EPC STORMWATER REVIEW COMMENTS IN ORANGE BOXES WITH BLACK TEXT

PURPORTED STREET ADDRESS:
9025 Chicago Avenue
DATE: 3/8/2023
CLIENT: Mierkey
JOB NUMBER: 231076

v1_Site Development Plan - REDLINES.pdf Markup Summary

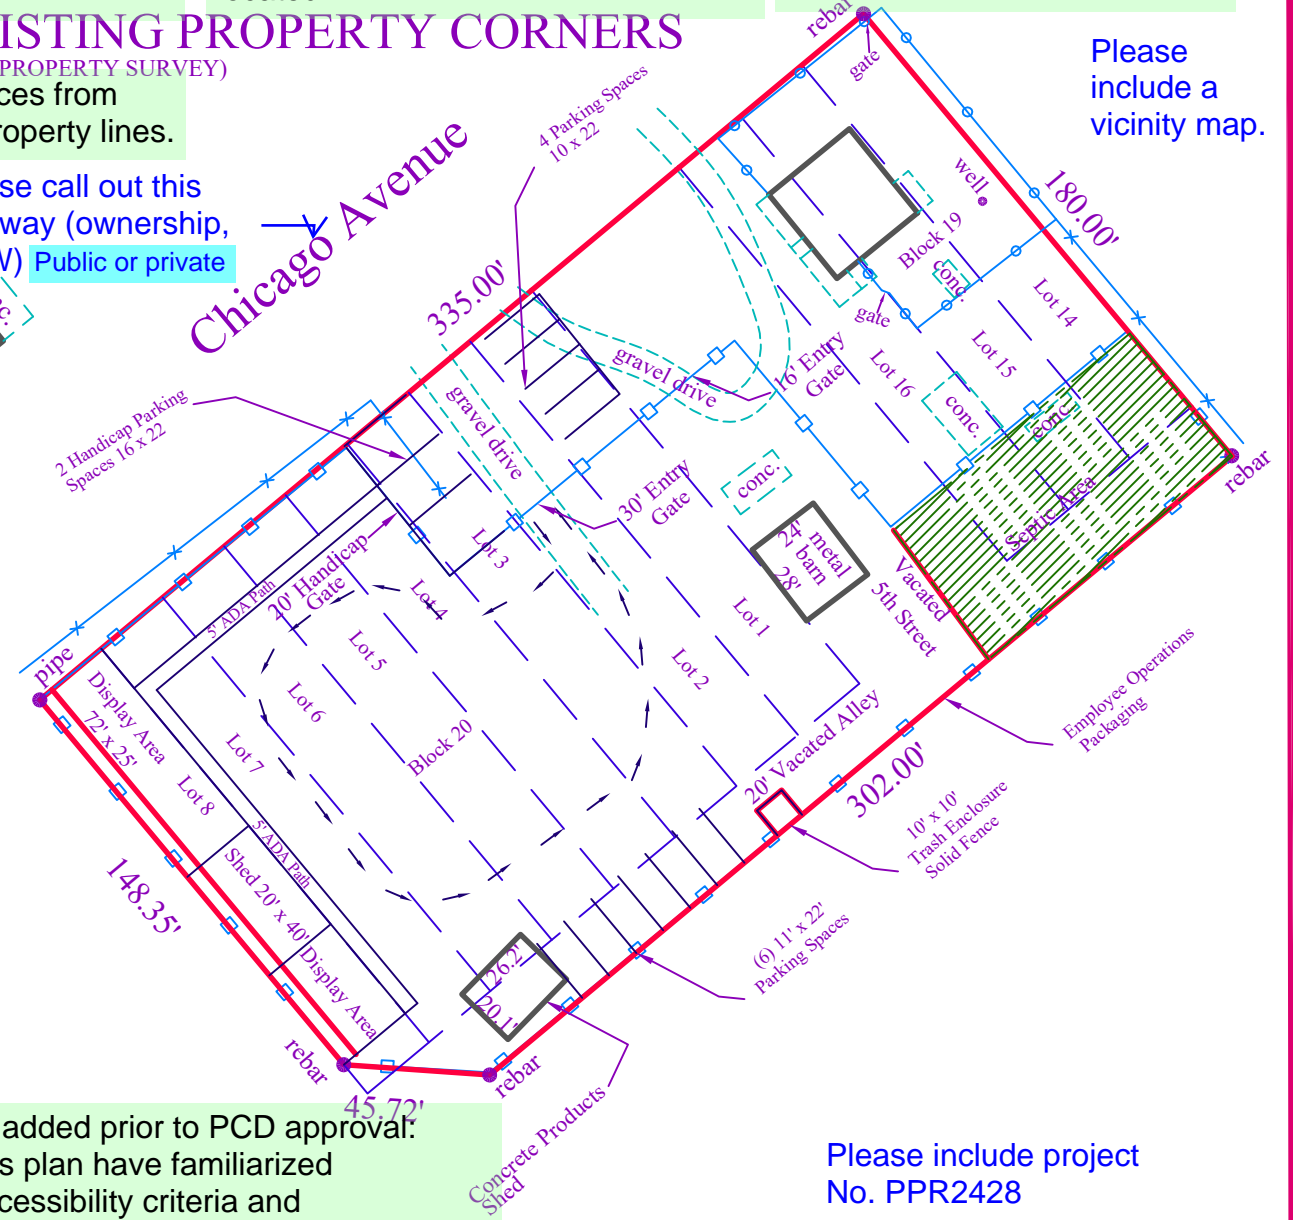
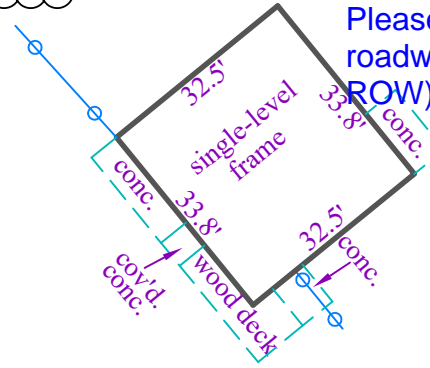
Include a scale.

Include a signature block for the PCD Director a minimum of 1" x 2"

Show where the sign will be located on the fence.

Show were landscape areas are to be located.

Show location of existing water infrastructure.

Please include a vicinity map.

Provide setback distances from each structure to the property lines.

Please call out this roadway (ownership, ROW) Public or private

Clarify what is existing and what is proposed. The drainage report states that the only change is to add a 20'x40' shed but the letter of intent and this plan seem to indicate more proposed work. It needs to be clear throughout what is existing and what is proposed. We need to know the total site disturbance.

Items 1-13 of the checklist are to be included in a summary data table. A few of the items are scattered around the page, but this sheet still must include the following information:
1. Owner/Applicant name, telephone number, and email.
2. Property tax schedule number
3. Lot/parcel size
4. Lot area coverage calculation
5. Zoning
6. TOTAL gross building square footage
7. Open space, landscaping, and impermeable surface percentage
8. Parking computations (required and provided)

Provide height of all fencing on the site.

The following note should be added prior to PCD approval:
The parties responsible for this plan have familiarized themselves with all current accessibility criteria and specifications and the proposed plan reflects all site elements required by the applicable ADA design standards and guidelines as published by the United States Department of Justice. Approval of this plan by El Paso County does not assure compliance with the ADA or any regulations or guidelines enacted or promulgated under or with respect to such laws.

Please include project No. PPR2428
